Access Compliance Report

Public Rights-of-Way

(Curb Ramps)

Intersection ID: 54269	Main Street: JOHNSTON_OEHLER_RD	Cross Street: OEHLER_BRIDGE_DR	Location:	E
ADA ID: 1DA726850D57	Ramp Type: Perp	Initial Pass/Fail: Pass	Overall Compliance: No	Severity Score: 0
Codes/Mitigation Info/Possible Solution		Field Measurements/Component Compliance

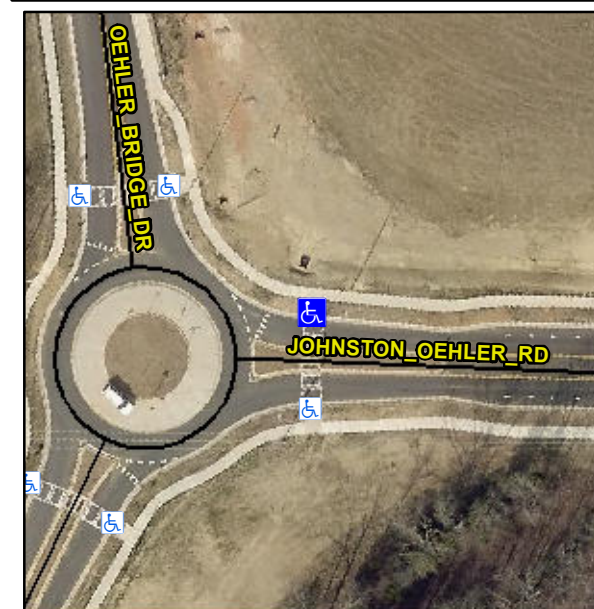
Remove & Replace Landing. Gutter Ponding Observed.
